Ilonka Aylward  
v.  
City of Charlotte  
and  
Charlotte-Mecklenburg Stormwater Services (a.k.a. “Charlotte Stormwater Services,”  
a.k.a. “Charlotte/Mecklenburg Storm Water,” a.k.a. “Charlotte Storm Water Services,”  
a.k.a. “City of Charlotte Storm Water Services”)  
and  
Armstrong Glen, P.C.  
and  
Joseph (“Josh”) H. Letourneau, P.E.

## **Exhibit 13**

**From:** Ilonka Aylward [ilonka.aylward@aylwardfamilylaw.com](mailto:ilonka.aylward@aylwardfamilylaw.com)   
**Subject:** Hinsdale Tinkerbell Stormwater Project Problems  
**Date:** June 27, 2019 at 5:51 PM  
**To:** Michael Davis [madavis@ci.charlotte.nc.us](mailto:madavis@ci.charlotte.nc.us), Desai, Kruti [kdesai@ci.charlotte.nc.us](mailto:kdesai@ci.charlotte.nc.us)  
**Cc:** Ilonka Aylward [ilonka.aylward@aylwardfamilylaw.com](mailto:ilonka.aylward@aylwardfamilylaw.com)

Subject: Evaluation of Potential Impact to 2813 Hinsdale St. by a Proposed Charlotte Mecklenburg Storm Water Drainage Improvements Project

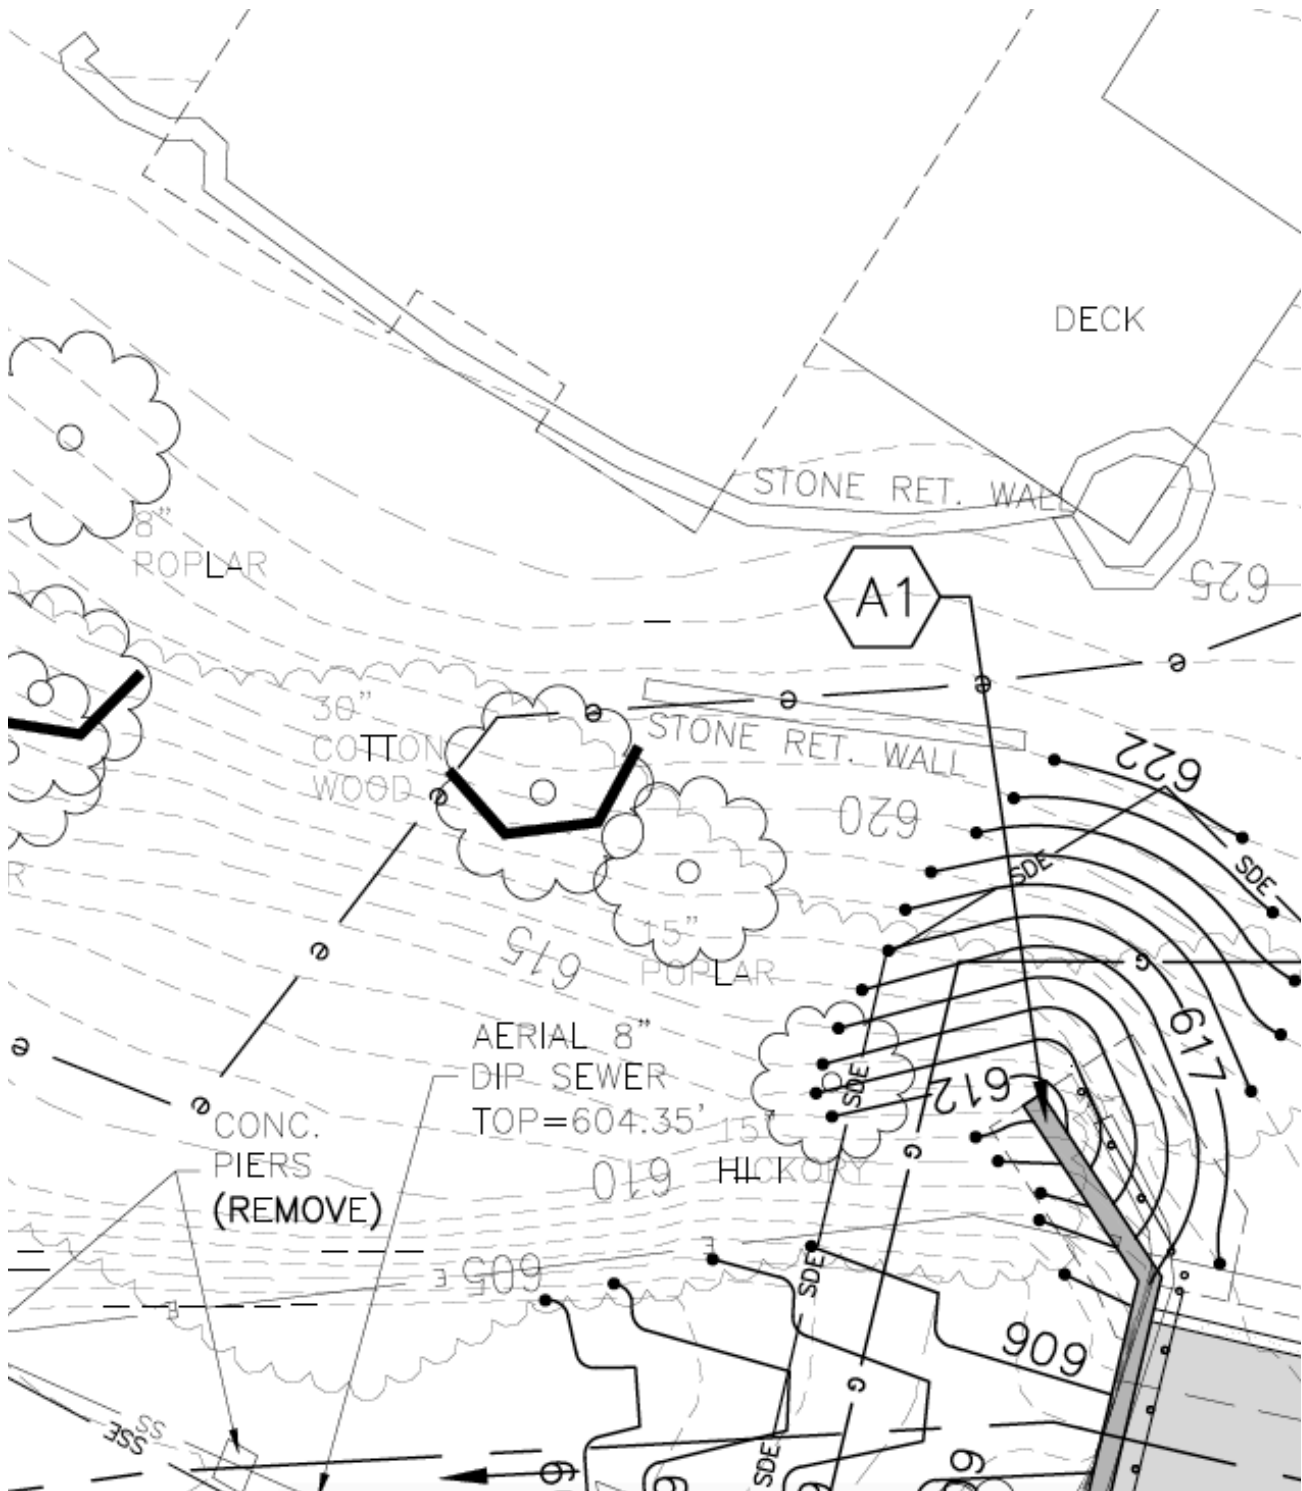
### **I. Non-Complaint, Unnecessary, Grading Will Compromise Steep Slope and Threaten Structural Integrity of the House**

Charlotte Stormwater wants to grade at least 16 vertical feet. This grading is not in compliance with *Charlotte Land Developmental Grading Standards Manual II(A)(10)*.

(at a minimum, 2:1 is not observed)

***Attach. 7*** Close up of proposed grading.

Diamond Engineering PLLC's Opinion Letter warns of structural damage to my house as a result of grading this "unstable slope," "subject to failure and erosion," "uncomfortably close to my house."

Importantly, Diamond Engineering PLLC Opinion Letter offers affordable and sustainable solution that will no cost any additional money:

Rotate the end of wing wall toward the creek;  
Store all the machinery *on my land!* but on the the left side of the creek.

Plus, City will even have to buy less of my land. Diamond Engineering opines that City will only need below contour 616, instead of all the way to the house at 625.

**Attach 8. (close up of stormwater design)**

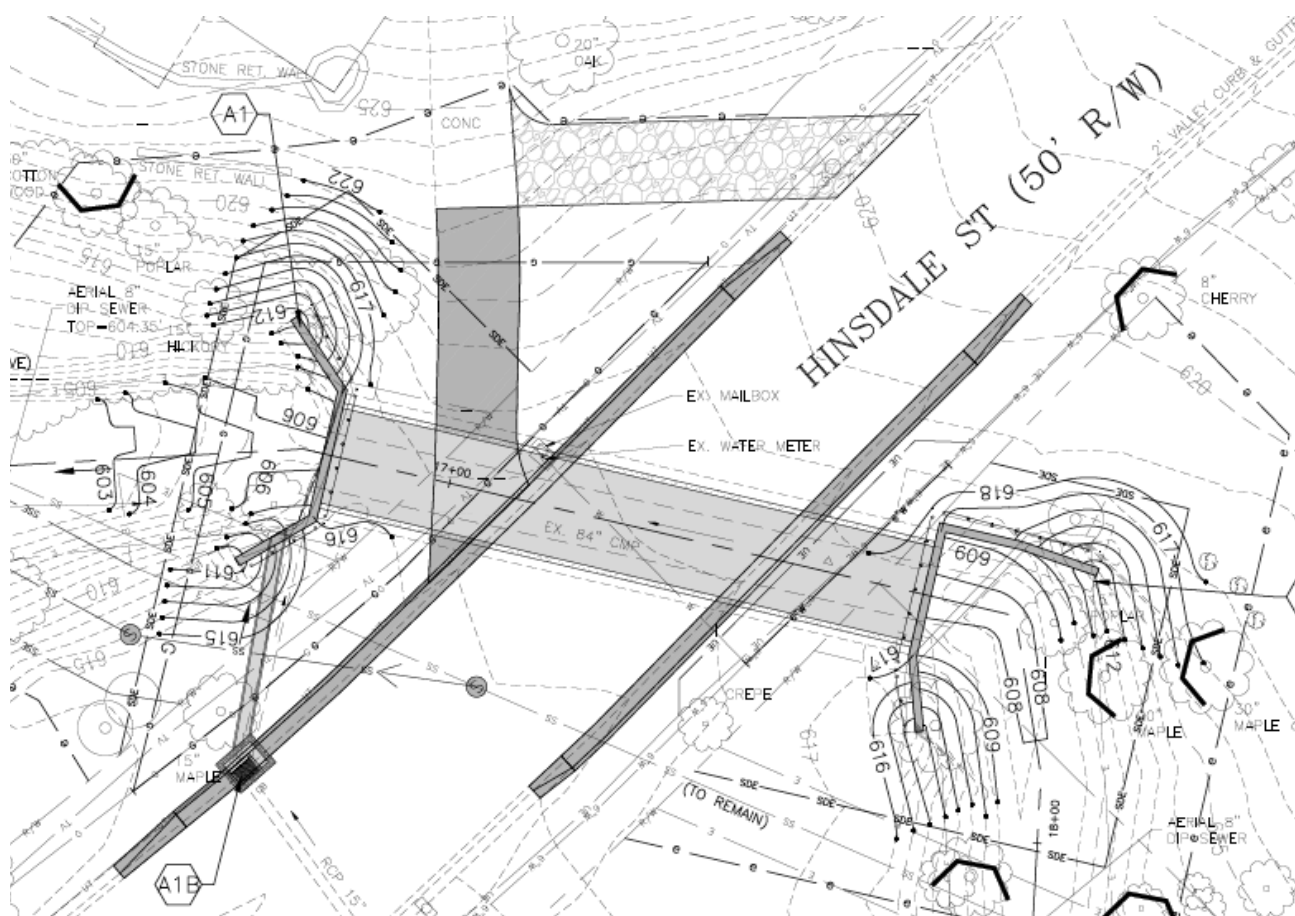
What's more, Stormwater uses this exact design on the other side of the culvert (see A2, across Hinsdale).

Stormwater (by Mr. Keene and Mr. Lozner) resists re-designing my A1 to look like neighbor's A2 saying that "consultants charge money to re-draw" and also saying (untruthfully) that "permits would have to be re-obtained." In reality, Stormwater has not yet applied for any CWA permits, according to all three CWA issuing agents.
